American Telecommunications Certification Body Inc.  
6731 Whittier Ave, McLean, VA 22101

RE: CANHOLD INTERNATIONAL LIMITED

FCC ID: RRSBTHF009

After a review of the submitted information, I have a few comments on the above referenced Application.

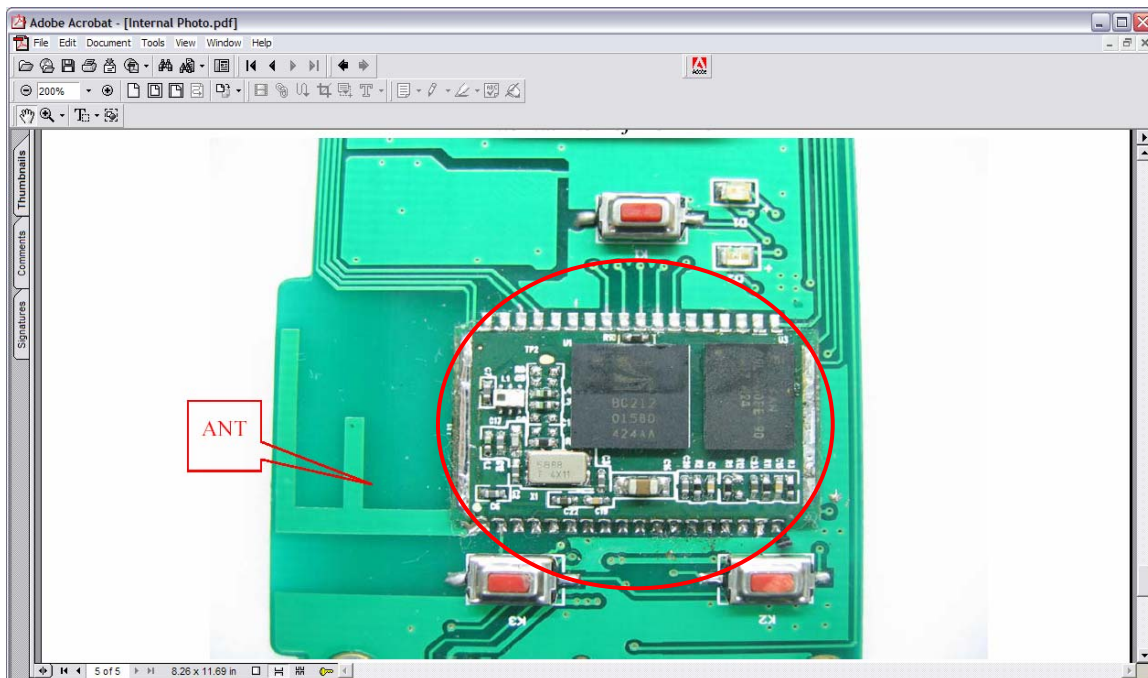
- 1) Please provide bottom view of the RF module/board shown:
